Watts Bar Nuclear Plant, Unit 1
Facility Operating License No. NPF-90
NRC Docket No. 50-390

Subject: Response to NRC Request for Additional Information Related to Application to Modify Watts Bar Nuclear Plant, Unit 1 Technical Specifications Regarding AC Sources - Operating (TS-WBN-13-02) (TAC No. MF2549)

ENCLOSURE
Watts Bar Nuclear Plant, Unit 1
Response to Request for Additional Information,
Offsite Power Availability Requirements

Figure 1

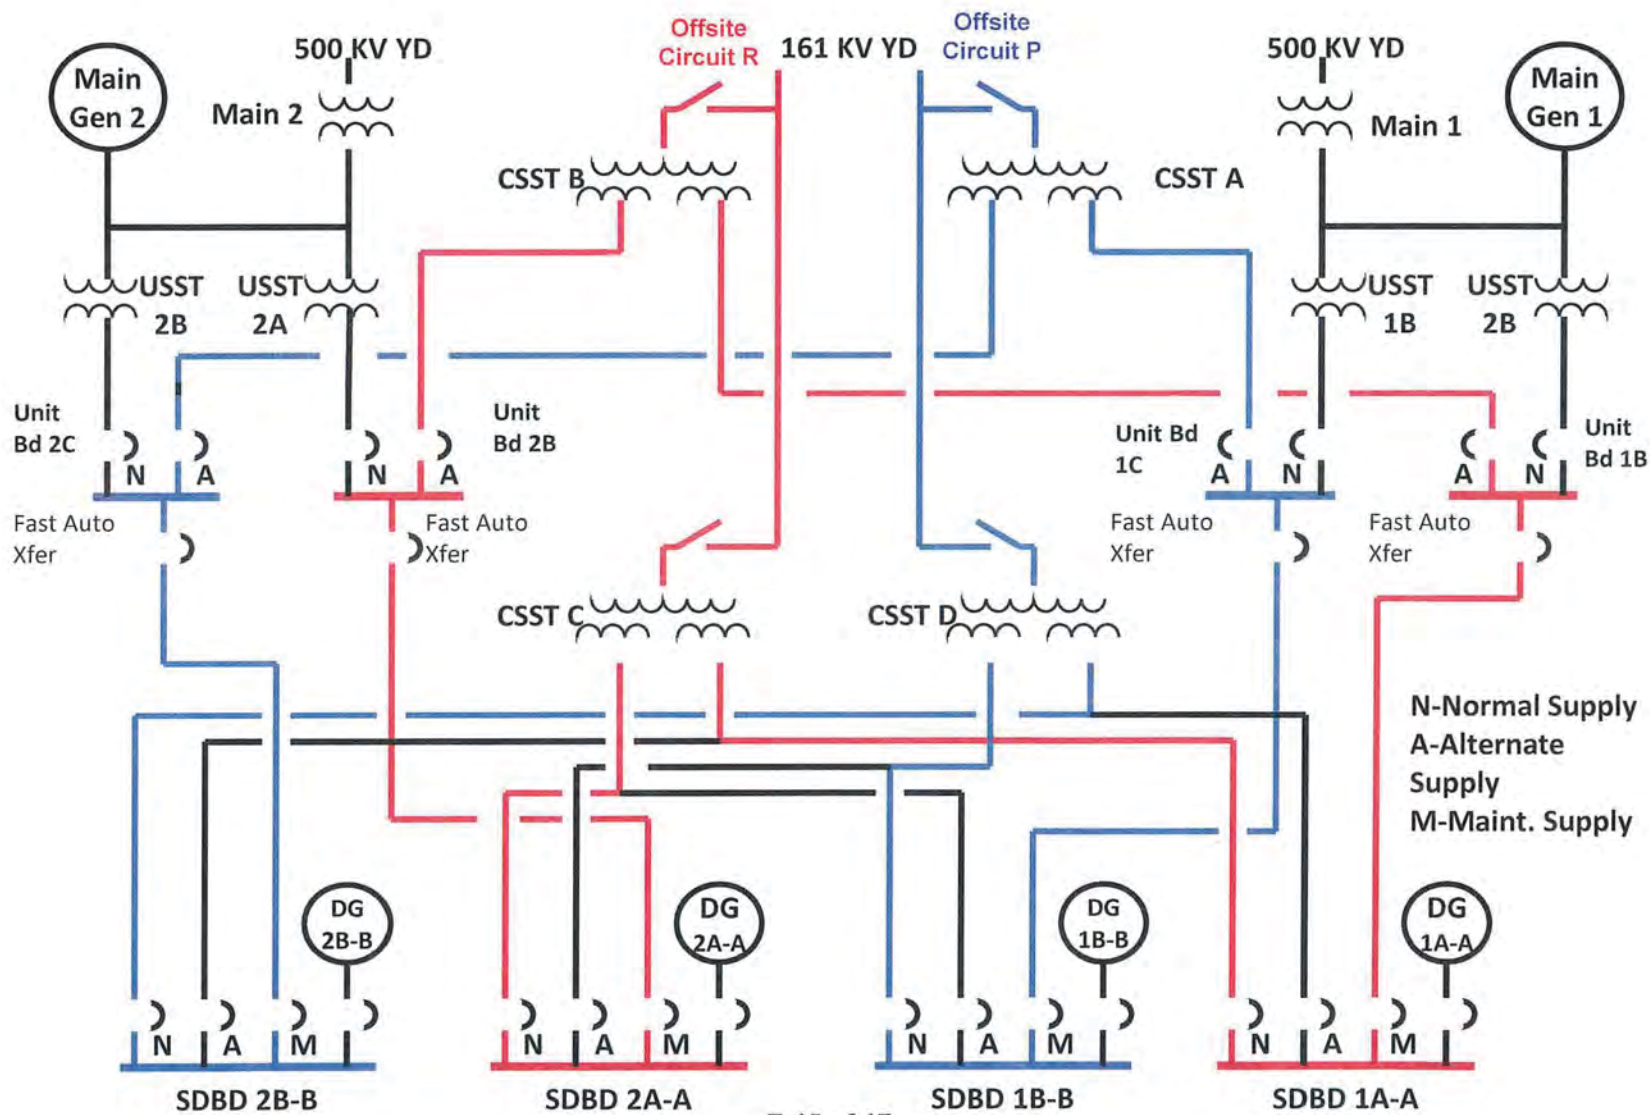
In case of a LOOP event, the onsite power sources are required to connect to the safety busses. In order to recover from a LOOP or a station blackout (SBO) event, the offsite power sources have to be restored to the safety busses. The current TS surveillances validate the capability to parallel the onsite and offsite sources for successful transfer between the two sources through CSSTs C and D. To demonstrate operability of a power source, the licensee has to perform periodic surveillances in their required power source alignment to comply with the requirements of 10 CFR 50.36. The current TS proposal to use CSST A or B as GDC 17 sources does not appear to have TS surveillances to validate a similar capability. Please provide information on surveillances that will be performed to demonstrate the operability of the circuits between the switchyard and the safety busses through CSST A or B.

When all 6.9 kV shutdown boards are aligned to their normal source, or all 6.9 kV shutdown boards are aligned to their alternate source, the automatic transfer to the alternate source is not required to comply with GDC 17. See Figure 1 below for the following discussion. More specifically, under the alignment when each of the shutdown boards is supplied from its normal source (Shutdown Boards 1A-A and 2A-A supplied from CSST C and Shutdown Boards 1B-B and 2B-B supplied from CSST D), each of the circuits (P and R) are available in sufficient time (i.e., immediately) following a loss of all onsite alternating current (AC) power supplies and the other offsite electric power circuit, to assure that specified fuel design limits and design conditions of the reactor coolant pressure boundary are not exceeded. In addition, under that same alignment, each of these circuits (P and R) is available within a few seconds (i.e., immediately) following a loss-of-coolant accident (LOCA) to assure that core cooling, containment integrity, and other vital safety functions are maintained.

Similarly, when all shutdown boards are aligned to their alternate source (Shutdown Boards 1A-A and 2A-A supplied from CSST D and Shutdown Boards 1B-B and 2B-B supplied from CSST C) each of the circuits (P and R) are available in sufficient time (i.e., immediately) following a loss of all onsite AC power supplies and the other offsite electric power circuit to assure that specified fuel design limits and design conditions of the reactor coolant pressure boundary are not exceeded. In addition, under that same alignment, each of these circuits (P and R) is available within a few seconds (i.e., immediately) following a LOCA to assure that core cooling, containment integrity, and other vital safety functions are maintained. Under these alignments (all aligned to normal or all aligned to alternate) the normal-to-alternate fast transfer is not required to comply with GDC 17.
